SUBJECT: Durham County, Widening of US 15-501 from North of SR
2294 (Mt. Moriah Rd) to South of SR1116 (Garrett Rd);
T.I.P. Number U-4012; WBS No. 35012.1.1; State Project
No. 8.1352301

SUBJECT: Action ID 200020945; TIP No. U-4012

Subject: Modification to the 401 Water Quality Certification Pursuant to Section 401 of the Federal Clean Water Act with ADDITIONAL CONDITIONS for Proposed widening of US 15-501 in Durham County, Federal Aid Project No. NHF-15(8), State Project No. 35012.1.1, TIP No. U-4012. DWQ Project No. 20042000 ver.2

PROJECT REFERENCE NO. U-4012	SHEET NO. 7
RW SHEET NO.	
ROADWAY DESIGN ENGINEER	HYDRAULICS ENGINEER
Permit Drawing	
Sheet 7 of 15	
PRELIMINARY PLANS DO NOT USE FOR CONSTRUCTION	
Revised 1/26/08

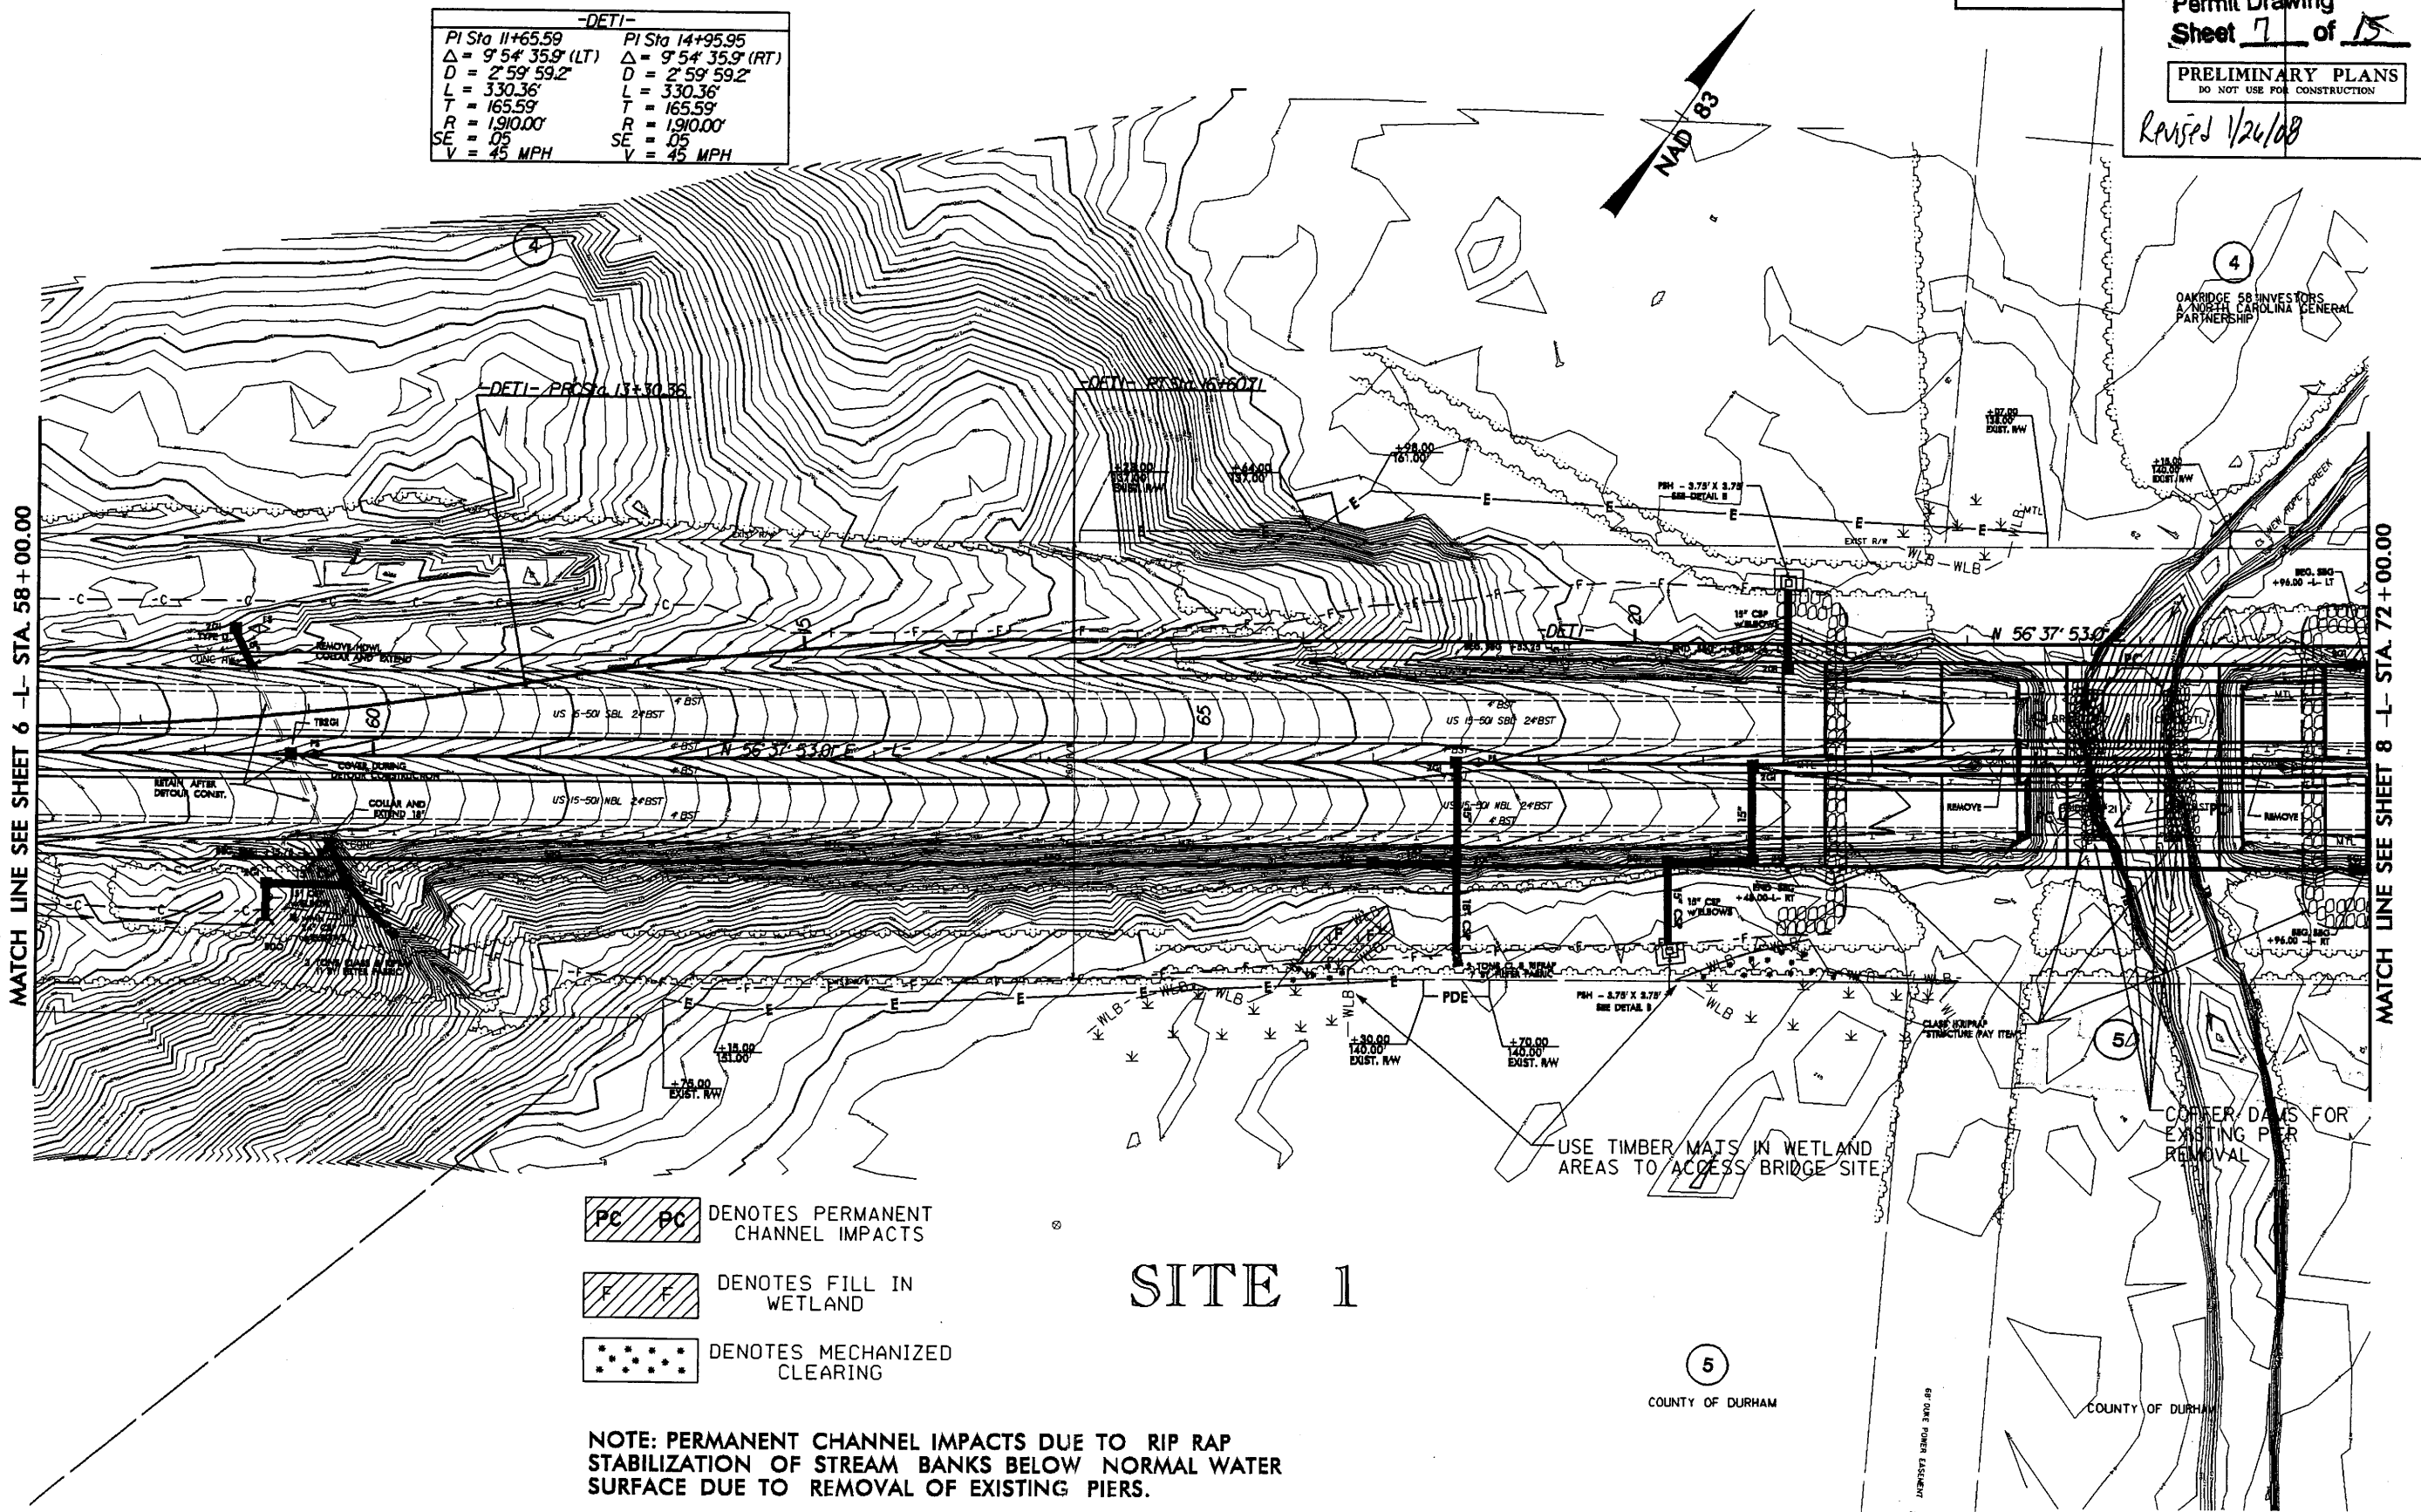
NOTE: PERMANENT CHANNEL IMPACTS DUE TO RIP RAP STABILIZATION OF STREAM BANKS BELOW NORMAL WATER SURFACE DUE TO REMOVAL OF EXISTING PIERS.

COVER DAMS FOR EXISTING PIER REMOVAL

Const. Rev. - Additional Rip Rap added around the bridge piers of the existing US 15-501 bridges to match the Structure Design plans. BCK 1-22-08

SEE SHEET 7 FOR PLANS

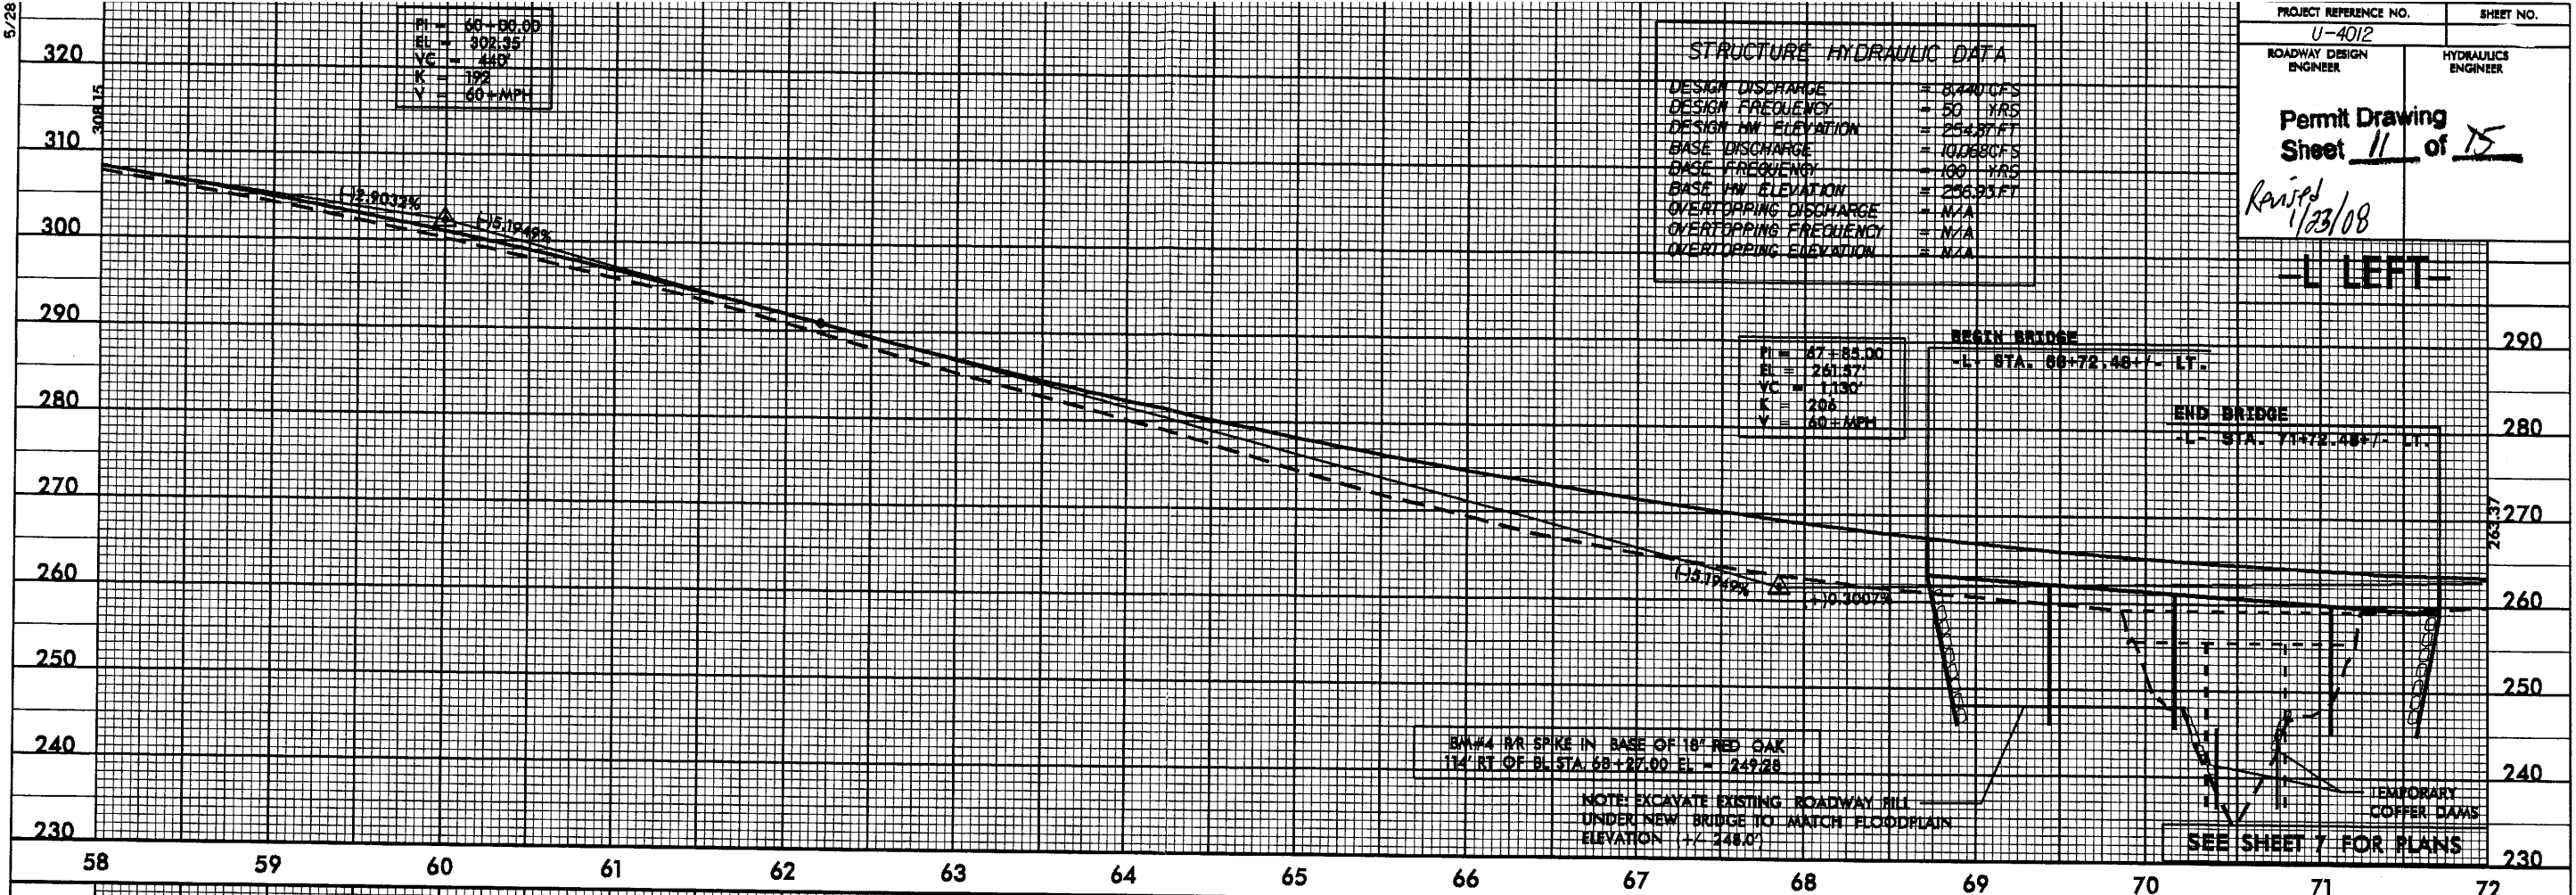
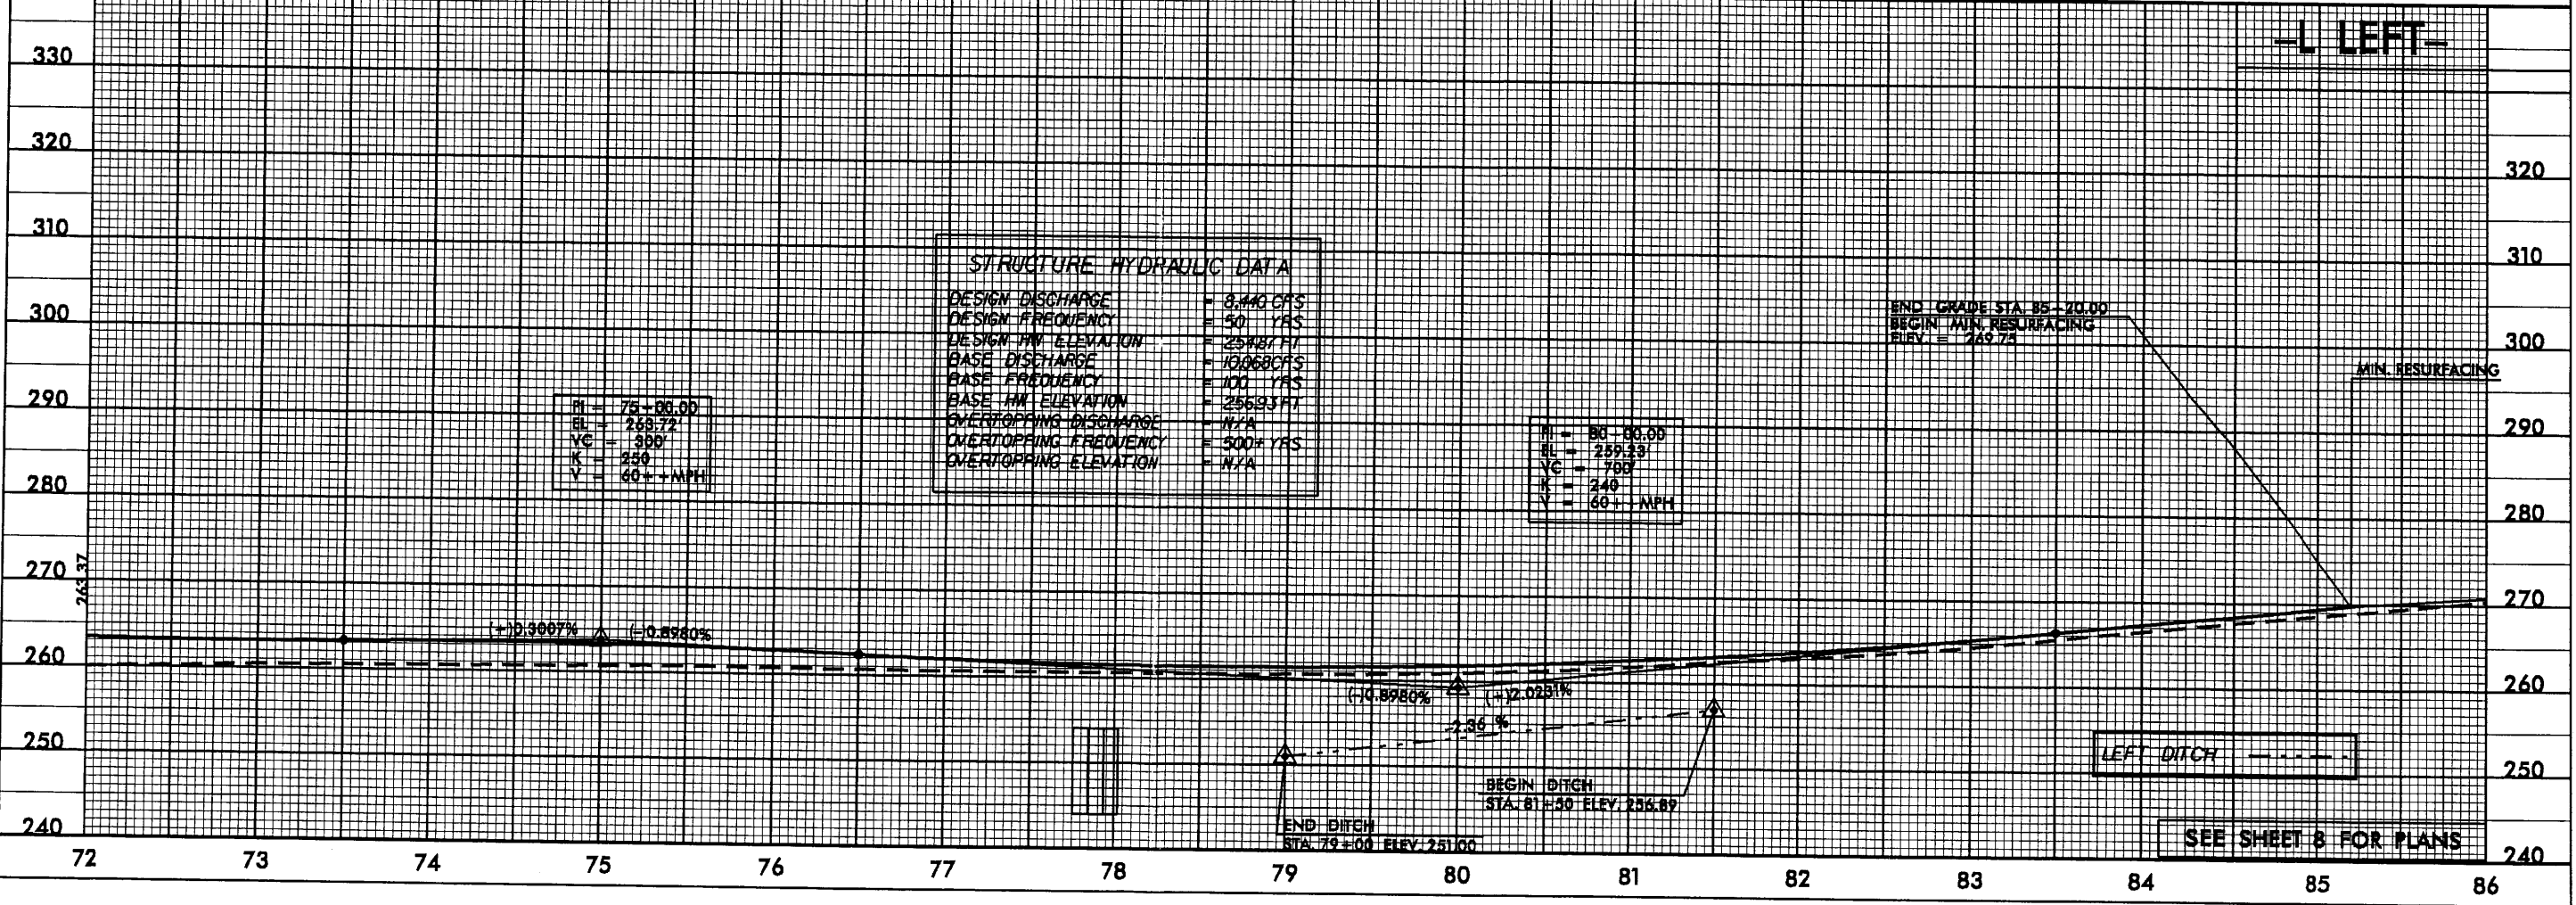
NOTE: EXCAVATE EXISTING ROADWAY HILL UNDER NEW BRIDGE TO MATCH FLOODPLAIN ELEVATION +/- 248.0'
